RE: Depleted Uranium Performance Assessment (DUPA)
Clive Facility
Model Version 1.4 Amended Interrogatories
Radioactive Materials License #2300249

**UTAH DEPARTMENT OF ENVIRONMENTAL QUALITY
ENERGYSOLUTIONS CLIVE LLRW DISPOSAL FACILITY
RML #UT 2300249**

STATUS OF INTERROGATORIES

Figure 13. Fifty realizations of saturated hydraulic conductivity $\log(K_{sat})$ and $\log(\alpha)$ developed by EnergySolutions using the method recommended in 2015 (from Table 2 of Appendix 21).

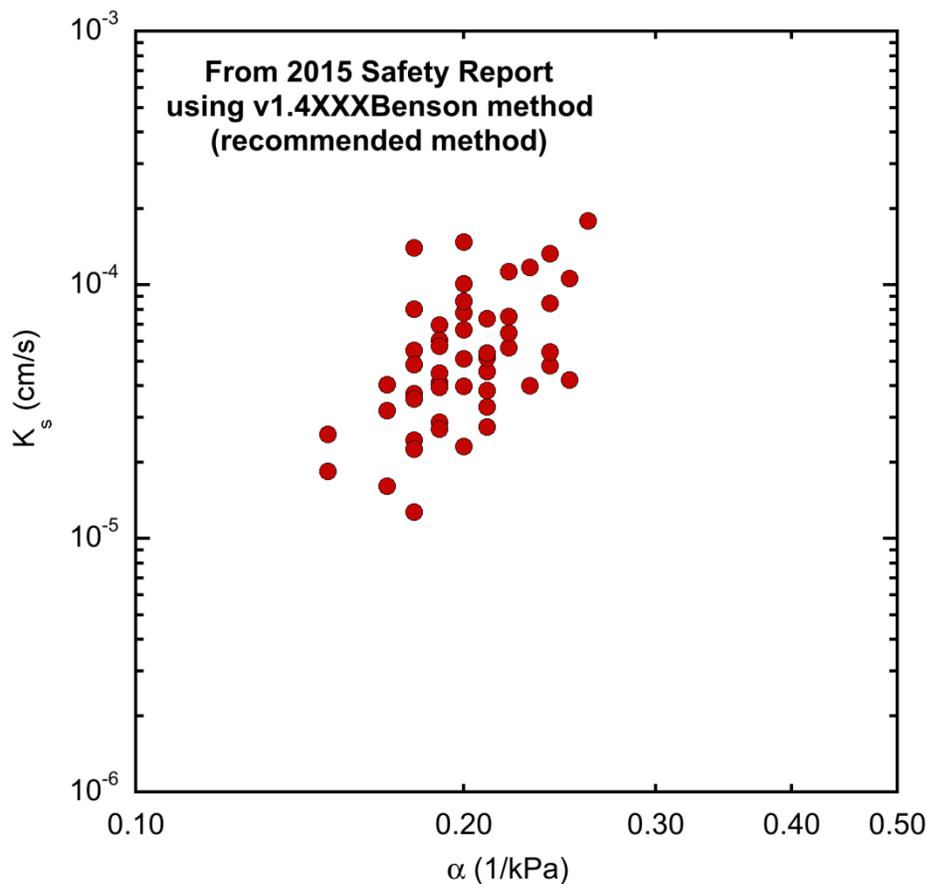
The hydraulic properties EnergySolutions developed based on the multivariate normal random generator as recommended by DEQ/SC&A are consistent with those in NUREG/CR-7028 for “naturalized” conditions. The cross-correlation structure between K_{sat} and α , based on $\ln K_{sat}$ and $\ln \alpha$, is also consistent with the literature, as shown in Figure 13.

EnergySolutions indicates that the lower-end standard deviation was used “to keep the input parameters within the ranges” of the 2015 Appendix E SER recommendation, which was not the intent of the recommendation. EnergySolutions should conduct their simulation using a typical standard deviation for each parameter. This will likely affect only the tails in the percolation data (high and low percolation rates in Figure 2 of Appendix 21) but likely will affect the 95th percentile doses (reported in Table 5 of Appendix 21).

Figure 17. Unit 3 bulk density probability distribution.

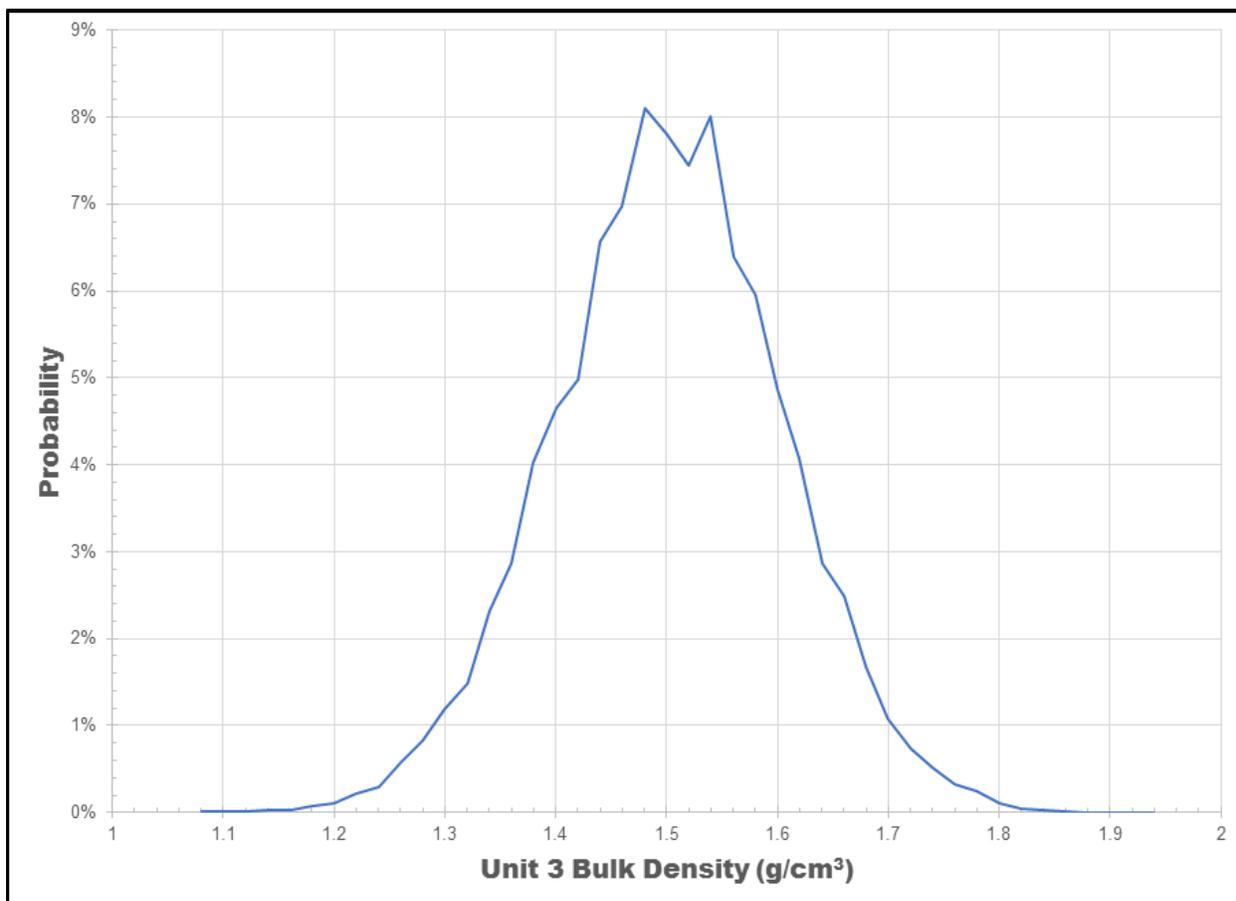
As shown below in Figure 17, using the data from DU PA v1.4, Appendix 5, Table 1 (Neptune 2015e), the Unit 3 density has the distribution shown in the figure, i.e., from about 1.1 to 1.9 grams per cubic centimeter (g/cm³) with a mean of about 1.6 g/cm³. It is not clear that “This value is consistent with previous modeling and the range of density determined by EnergySolutions (1.75 to 1.80 gm/cm³) for the compacted, in-place waste.”

Figure 18. DU PA GoldSim Model v1.4 Tc-99 well water concentration

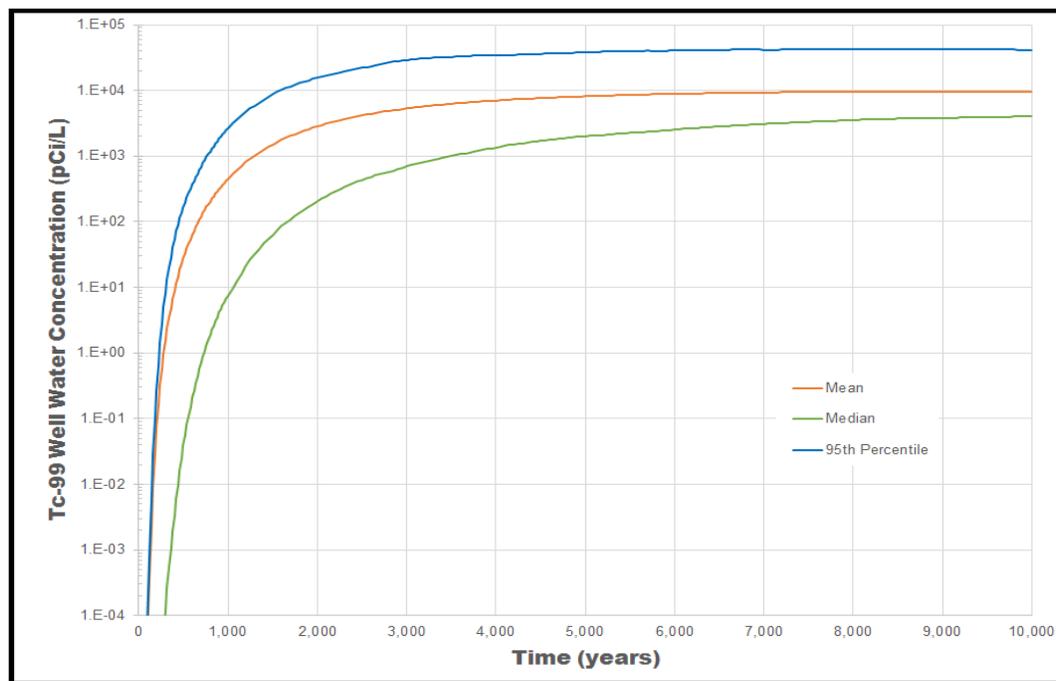
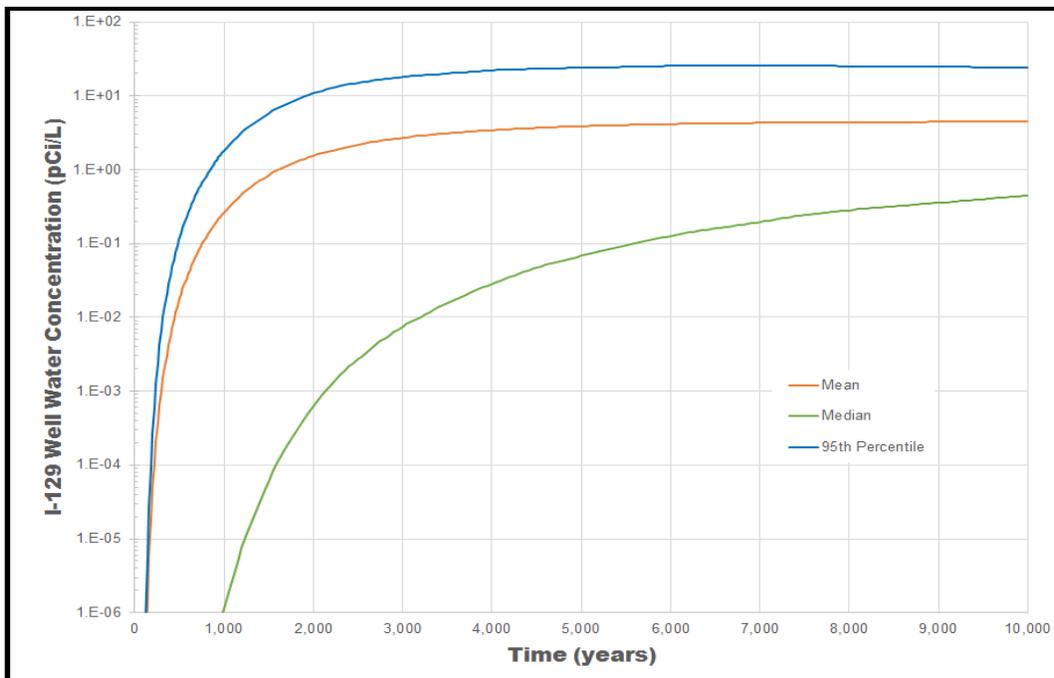
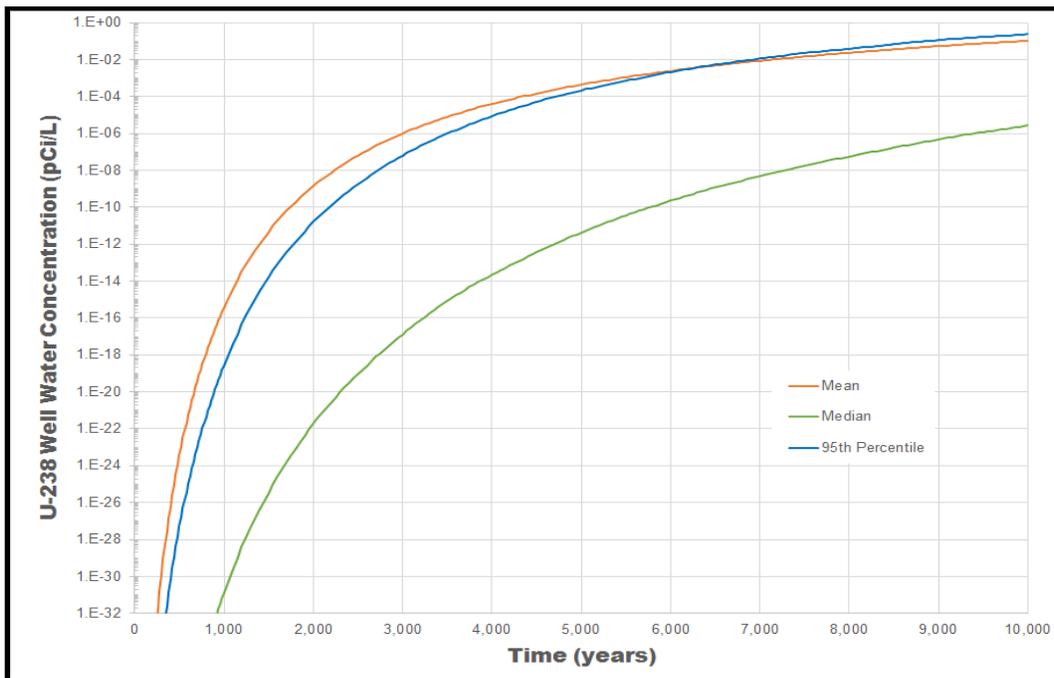
For Tc-99, iodine-129 (I-129), and uranium-238 (U-238), Figure 18, Figure 19, and Figure 20 below present the median, mean, and 95th percentile well water concentrations DEQ/SC&A calculated with the DU PA GoldSim model v1.4. To check the results, Table 7 compares the DEQ/SC&A calculated median, mean, and 95th percentile concentrations to those reported in Neptune 2015a, Table 2.

Since the Table 8 results are unexpected and seem to contradict the five references quoted above, please provide an explanation for why the DU PA GoldSim Model v1.4 uncertainty seems to be decreasing with increasing time.

Figure 21. Reproduction of DU PA v1.4 Appendix 10, Figure 2, using the GoldSim data lookup table FractionGully.

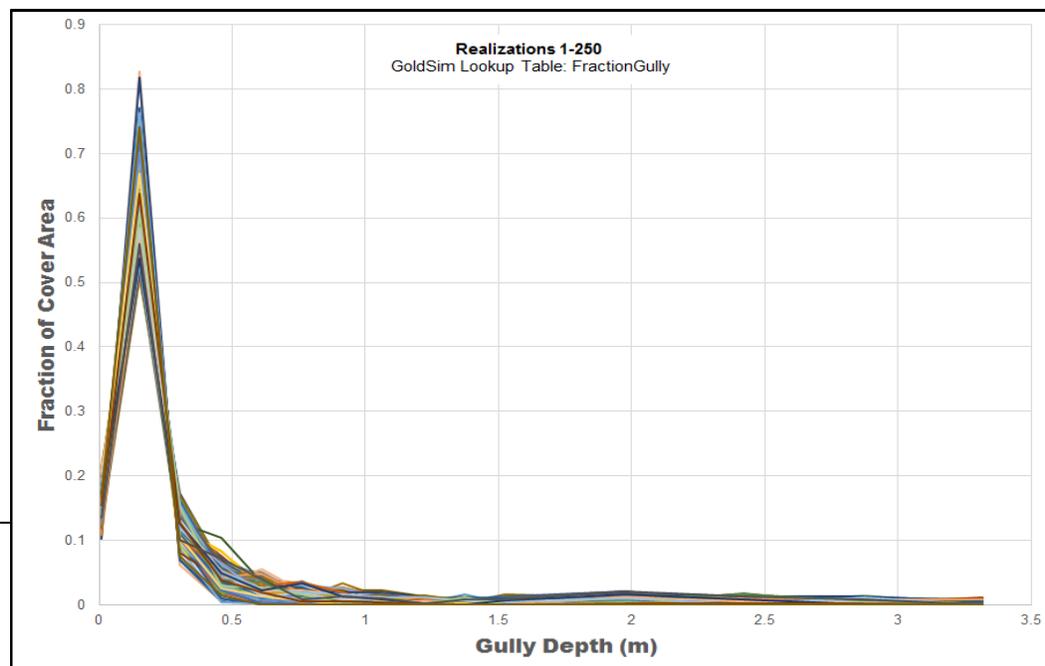
First, SC&A was able to reproduce DU PA v1.4 Appendix 10, Figure 2 using the GoldSim data lookup table: FractionGully (see Figure 21). FractionGully is a lookup table that has the results of the 1,000 realizations of the erosion analysis for 15 depths (the 11 cap layers (5 feet total) and four waste layers (0.4485 meter each)). FractionGully has very small percentages for the top cap layer (0.01 meter). This implies that erosion is greater than 0.01 meter almost everywhere on the embankment.

Finally, the text of DU PA v1.4, Appendix 10, Section 4.2 needs to be corrected to indicate that FractionGully is a volume fraction, and not a cover fraction. For example, the Figure 2 caption wording needs to be revised from “fraction of cover area” to “fraction of eroded volume,” and, likewise, the four y-axis titles shown in Figure 2 need to be corrected.

Figure 26. FractionGully as a function of embankment depth

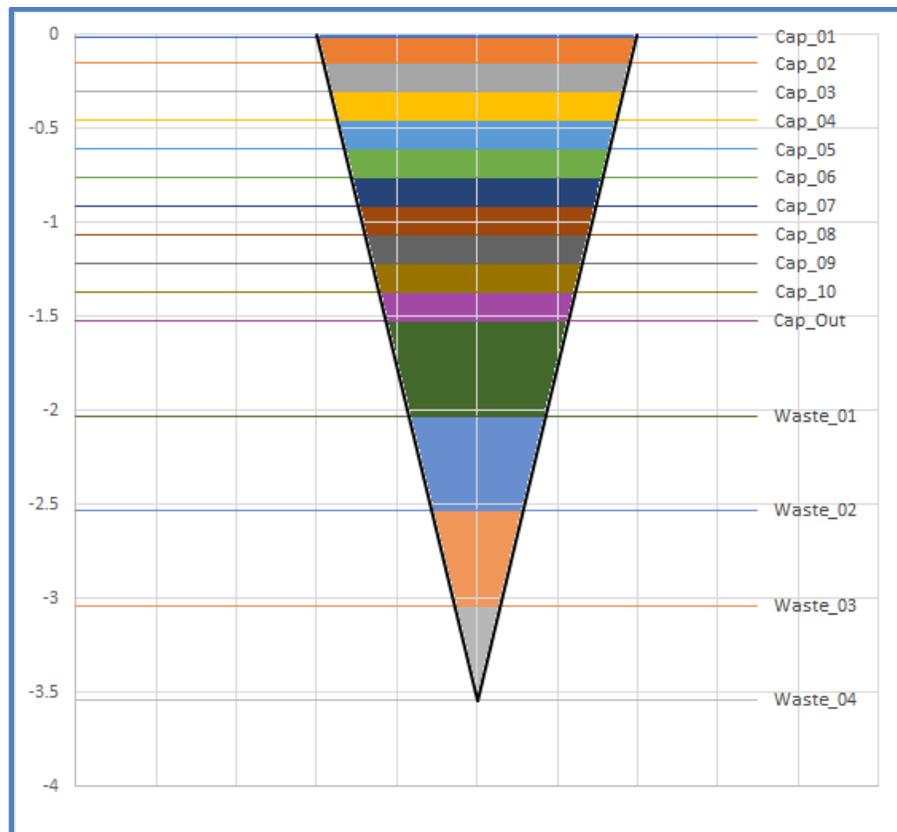
The FractionGully is the fraction of the eroded material that originates in each layer of the embankment. Thus, it is the product of the eroded embankment area and the thickness of the cap/waste layers. Because the waste layers are about 3.3 times thicker than the cap layers, the value of FractionGully in the first waste layers can be larger than in the last cap layer. This may be seen in Figure 26, which shows the cap layer and waste layer volumes getting progressively smaller, but at the transition from cap layers to waste layers, the volume gets larger (e.g.,

compare the purple and dark green volumes in Figure 26). This also explains why the 1-cm thick first cap layer FractionGully values are always significantly smaller than the second cap layer values.

However, there are problems with how the FractionGully parameter is used within the GoldSim v1.4 model. Because it is a volume fraction, it is appropriate to use FractionGully to calculate the WasteVolRemovedByGullyLowest parameter (which is misnamed, since the waste volume is calculated for all waste layers, not only the lowest). However, DU PA v1.4 also uses FractionGully to calculate the WasteAreaExposedGully parameter. This is incorrect; FractionGully must be adjusted for each layer's thickness before it can be utilized to calculate area.

Figure 29. Comparison of upscaled and non-upscaled infiltration rates

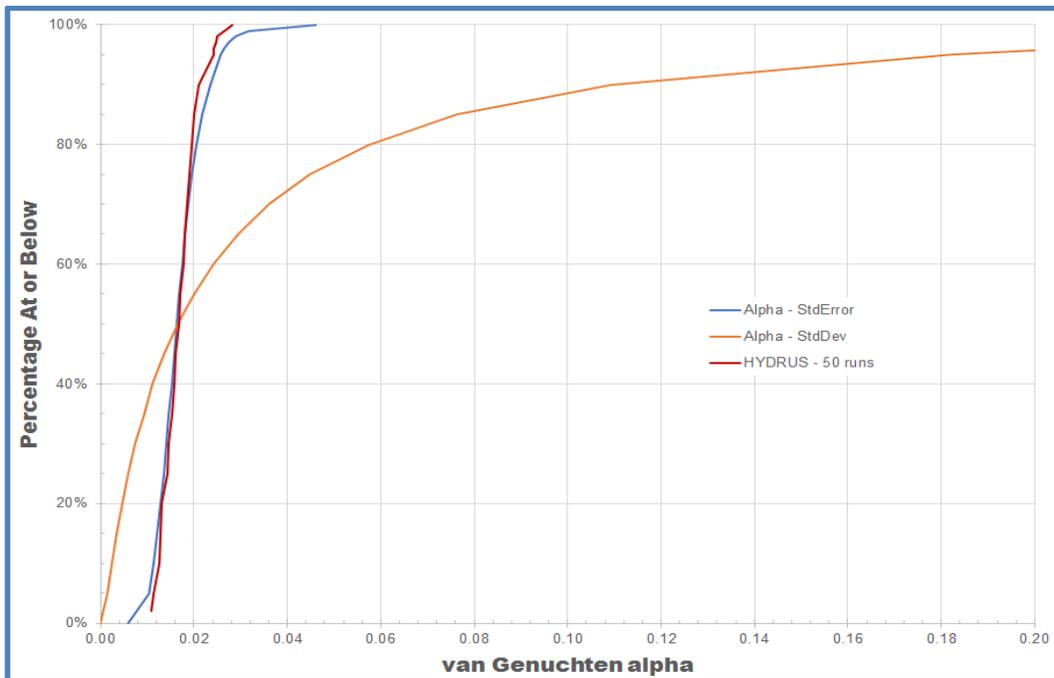
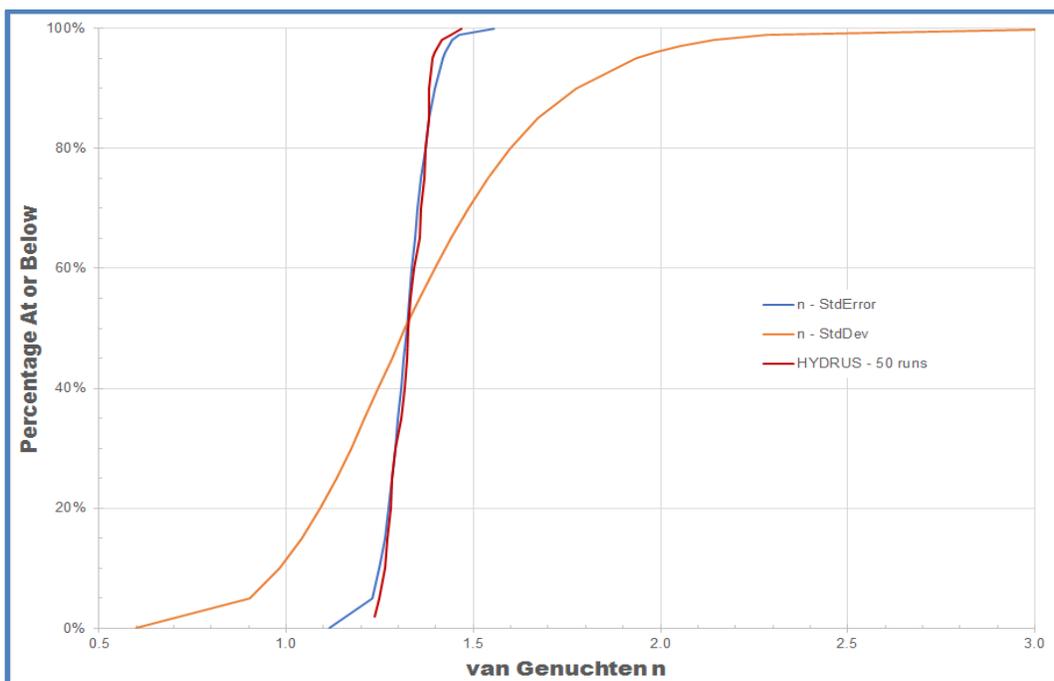
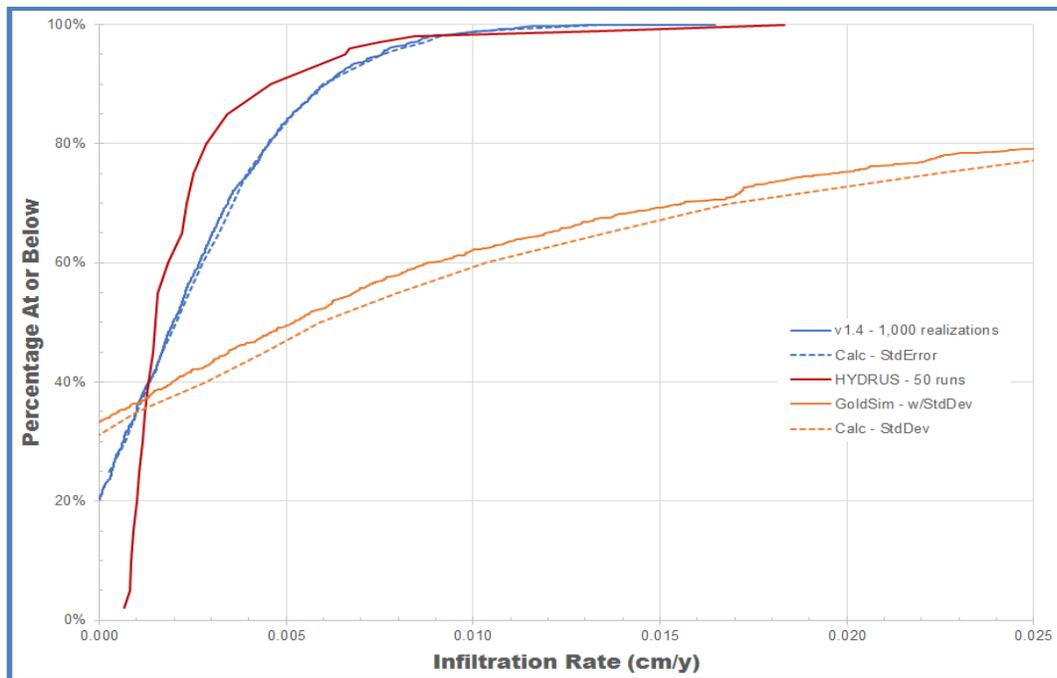
Figures 27 and 28 below show the van Genuchten α and n parameter distributions using both the standard deviation and the standard error methods, as well as the parameter distributions from the 50 HYDRUS runs. The tails from both standard deviation distributions extend well beyond the standard error distribution, as expected.

We do not have any HYDRUS runs beyond the standard error range. However, if we assume that the infiltration rate abstracted from the 50 HYDRUS runs applies over the standard deviation range for both α and n , then Figure 29 compares the infiltration rate calculated using the standard error distribution to the rate calculated via the standard deviation distribution.

Not shown in Figure 29 is the 95th percentile standard deviation infiltration rate, which was calculated to be 0.11 centimeters per year (cm/yr), compared to the standard error rate of 0.009 cm/yr.

Figure 33. GoldSim versus HYDRUS infiltration flux

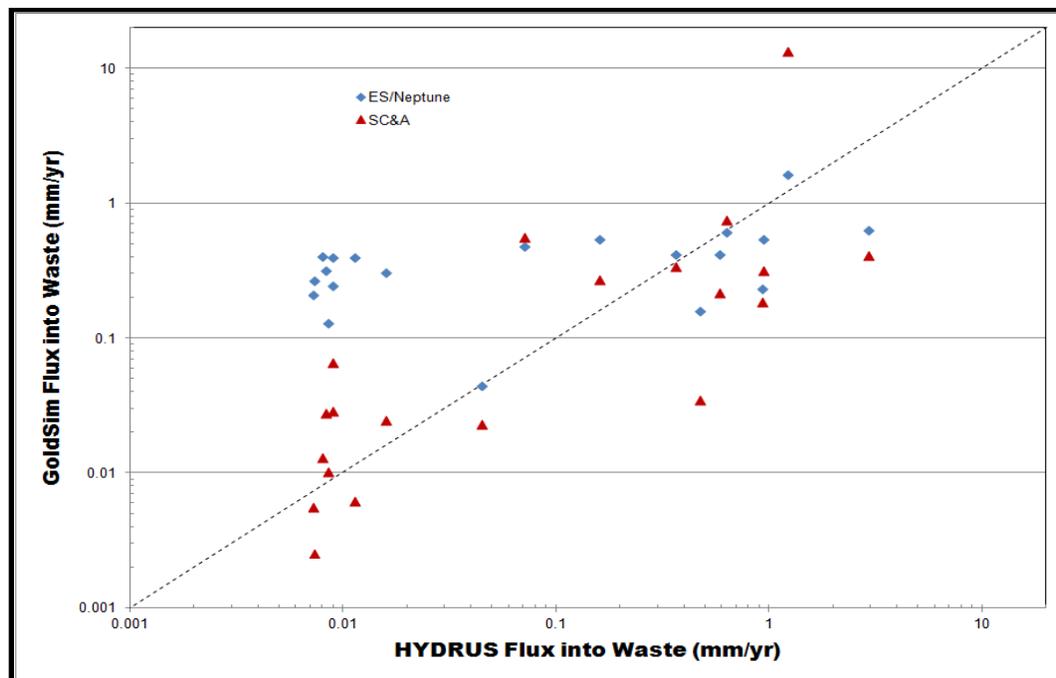
As an alternative to the linear regression, DEQ/SC&A fit an exponential equation to the van Genuchten α , n , and K_{sat} input data and the HYDRUS-calculated fluxes (Figure 33). The triangles shown in Figure 33 are the fluxes calculated using the following exponential fit: $\text{Flux} = 45.465 \times \alpha^{1.4408} \times n^{-1.332} \times K_{sat}^{-0.445}$. For large fluxes, the exponential fit does not appear to be much better than the linear fit, but for small fluxes (which tend to result when the van Genuchten α is small), the exponential fit is much better than the linear fit.
